Service Letter No. 345

SUBJECT: Hartzell Service Bulletin No. 75 - Inspection of Hartzell Governor for Presence of Vent Hole

MODELS AFFECTED: PA-23-250 Aztecs and
PA-24-250 Comanches - Equipped with Hartzell Model B4
Governors

UBJECT: Inspection of Hartzell Governor for Presence of Vent Hole

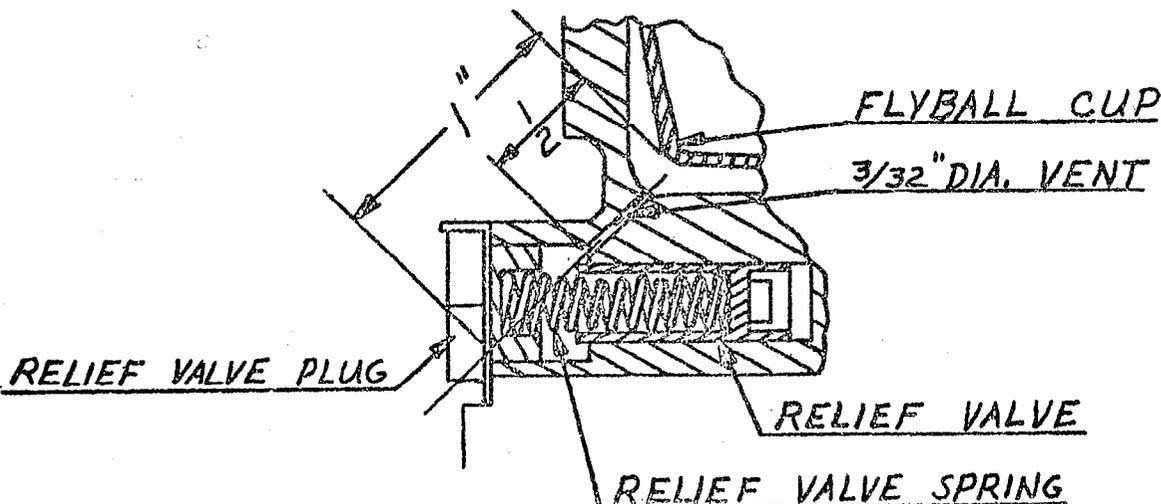
DISCUSSION: There have been several instances reported wherein excessive governor pressure ruptured the piston of the propeller. In every instance, this occurred during engine run up, when the oil was relatively cold and thick. Investigation of the Hamilton-Standard governor, modified to Hartzell specifications, revealed that a vent hole in the governor body was missing or plugged. This vent hole, which connects the spring side of the relief valve cavity with the flyball housing, prevents oil from locking the relief valve in the closed position. Governor bodies of certain model Hamilton-Standard governors do not have this vent present.

INSPECTION REQUIRED: Inspect the governor for presence of open vent hole:

1. Remove relief valve plug cap and spring, on side of governor.
2. Check visually for presence of open vent hole, as shown on sketch below:
 - (a) If vent hole is not present, drill one as described below.
 - (b) If vent hole is present, check to be sure it is open to the flyball housing. Use length of safety wire and insert it into the hole for the distance shown if possible. If vent is plugged, the wire cannot be inserted the full distance.
3. If vent hole is absent or plugged:
 - (a) Remove governor from engine
 - (b) Remove governor cap
 - (c) Remove plug, or drill vent as shown.

CAUTION!! Great care must be taken to insure that chips do not enter governor passages. Clean thoroughly.

4. Reassemble governor and reinstall on airplane.
